# **Service Letter No. 70**

SUBJECT:

Mislocation of Oil Temperature probes on Lycoming engine Maules incorporating two Separate Magnetos. This includes airplanes with the following Lycoming engines: O-320-B2D, O-360-C1F, O-360-C4F, O-540-J3A5, O-540-B4B5, IO-540-W1A5, and IO-540-V4A5. This does <u>not</u> apply to Lycoming engine Maules incorporating a single drive magneto.

#### Oil Temperature Probe correctly positioned:

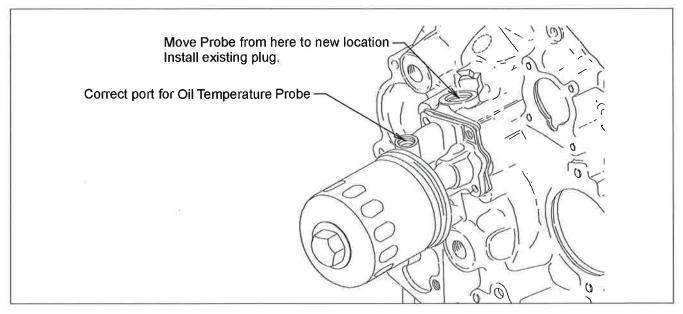
BACKGROUND: It has been discovered that the Oil Temperature probe is in the incorrect loca-

tion on Lycoming powered Maules which have <u>two</u> <u>Separate</u> Magnetos. The probe when in the incorrect location would register a higher temperature.

Relocate Oil Temperature Probe To correct port as shown on page 2:

Aircraft Model			
Aircraft Serial No		-	
Action taken (PLEASE CHECK if applicable):			
( ) Relocated O.T. Probe to proper port and p	lugged p	revious port v	vith existing plug.
Owner's Name			
Owner's Address			
City	State_		_Zip
Phone number(optional)			
Certified byTi	itle	Owner, A & P.	IA. Etc.
Date performed		=	
If you no longer own this airplane, please fill in new dress below:	owner's	information and	d return to factory ad-
New Owner's Name			
New Owner's Address			
City	State_		_Zip
If owner's email address has changed, please enter here:			
Please mail this completed Compliance Record Shords~2099 Georgia Highway 133 South~Moultrie, Or Fax to: 229-890-2402			Engineering Re-
